RSBG-6 & RSBG-8 SAFETY NOTICE

The machines affected were the following models;

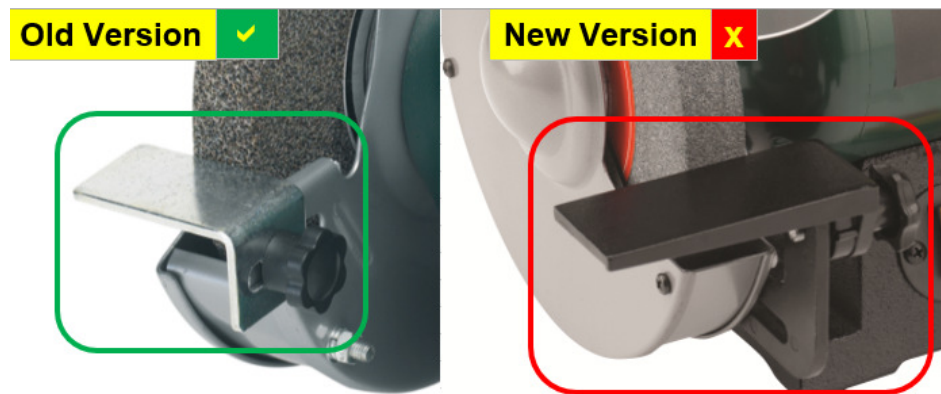
It has come to our attention that the initial batches of our new grinders have a non-conforming work rest, which does not allow for correct or compliant adjustment at all angles.

If the work rest of your bench grinder looks like the “**Old Version**”, your machine **IS NOT** affected!
If it looks like the “**New Version**”, your machine **IS** affected!

We have found that the bracket on our first batches of machines allows for this at 90°, but not when the work rest is tilted at certain angles.

The reason this is a safety issue and the standard recommend 2mm maximum is to reduce any risk of a workpiece being snatched downwards by the stone, trapped between the work rest and the stone and potentially causing the stone to fracture at speed, which could cause serious injury.

We are currently making new brackets to resolve this issue, which will require the simple addition of a spacer, washer and the new wing screw with correct dimensions. We expect the first batches of replacement parts to be available from 12 November 2018.

- 5mm spacer
- 3mm washer
- 16mm wing screw
